Permit Application Review

Permit No. 2021-170
Received complete: December 7, 2021

Applicant: Mike Kuno: City of Minnetonka
Consultant: Bailey Nelson; SEH
Project: 10-inch Sanitary Sewer Force main
Location: Between Green Circle Drive and the trail east of Boston Scientific – Opus II:
Minnetonka
Rule(s): 2, 3, 4, 5, 6 and 10
Reviewer: BCO

PLAN AND PROFILE
DEEP PIPE INSTALLATION

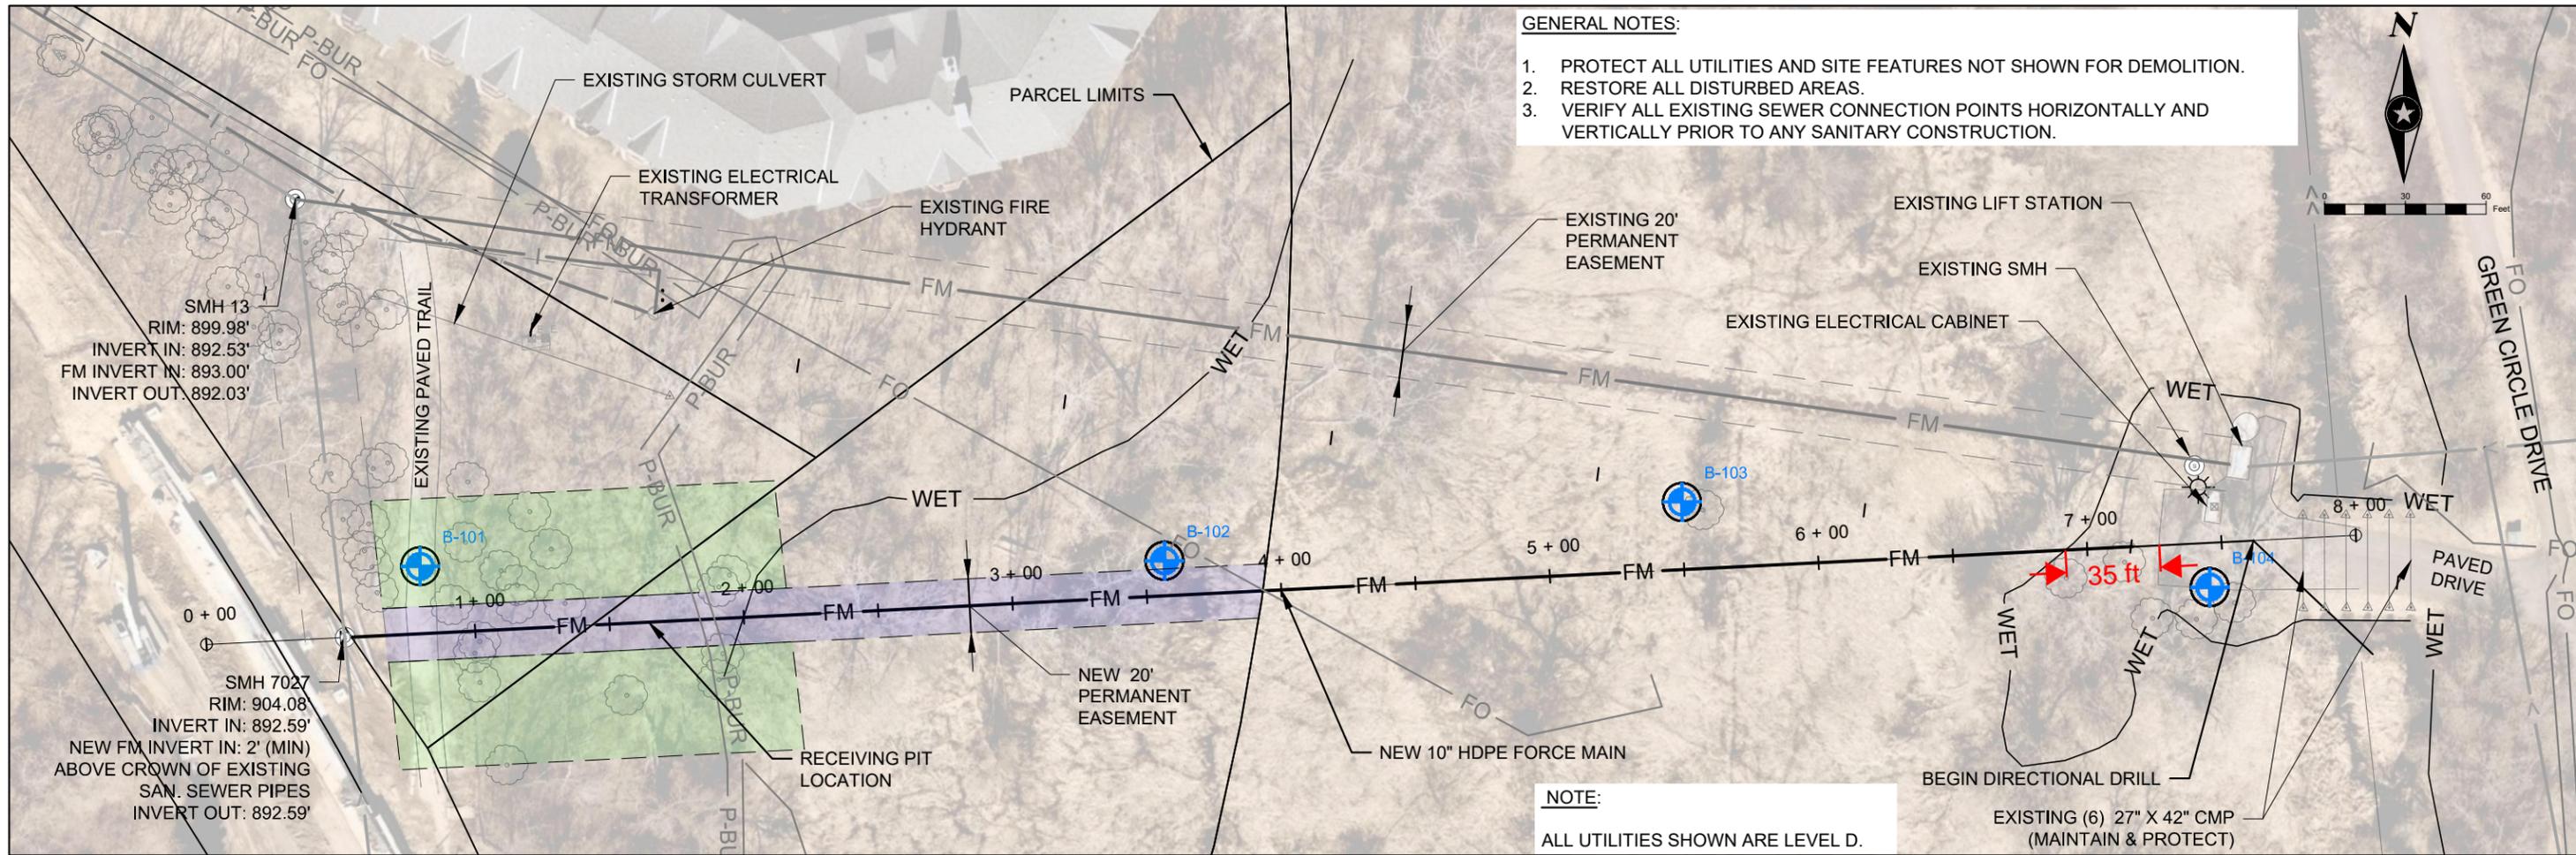
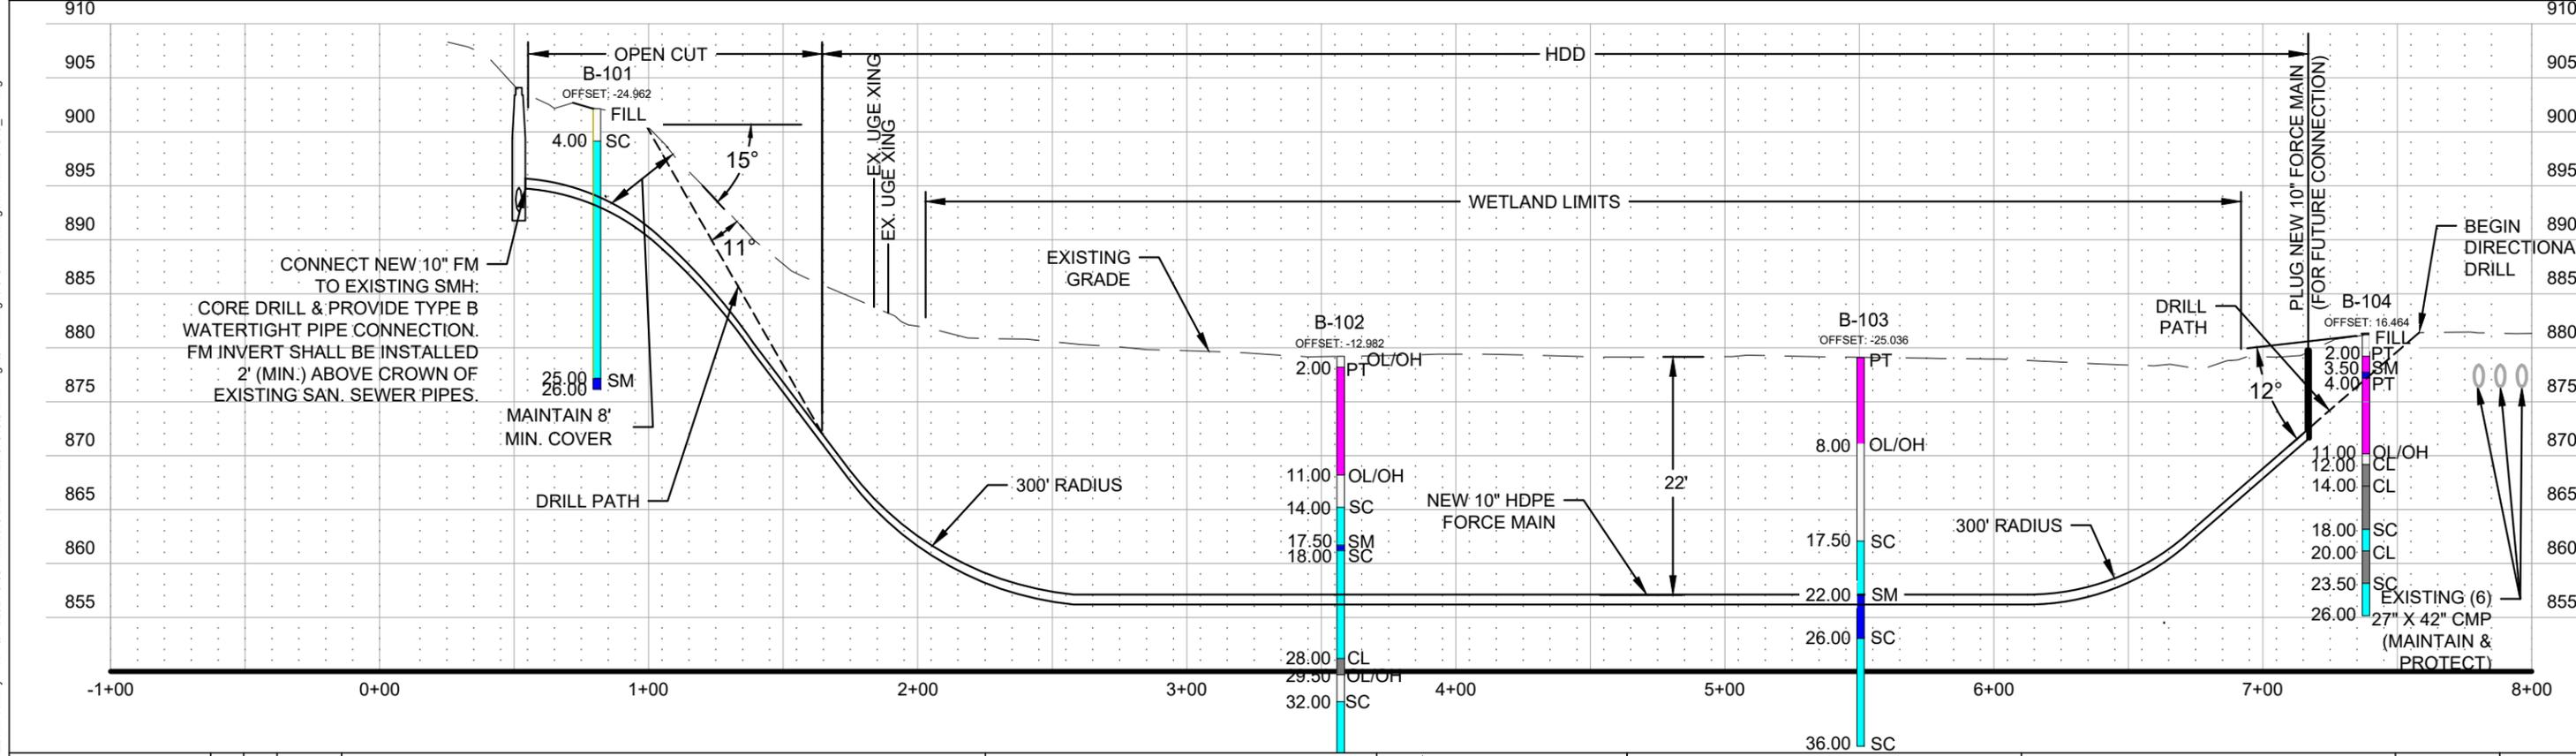
The sanitary sewer is to be installed at a depth of approximately 22-feet beneath the bottom of the wetland and no construction or disturbance is proposed within the wetland boundary. Therefore, there will be no impacts on the water quality of the wetland, change in the existing flowline/gradient, or increase scour, erosion, or sedimentation. Erosion control is proposed downgradient of the areas disturbed during construction. The disturbed areas are to be restored to an existing condition at the completion of construction.

Directional boring of the force main is proposed with the pipe to be approximately 22-feet beneath the bottom of the wetland. The work is not proposed adjacent to a stream therefore the setback distance of the directional boring pits does not apply.
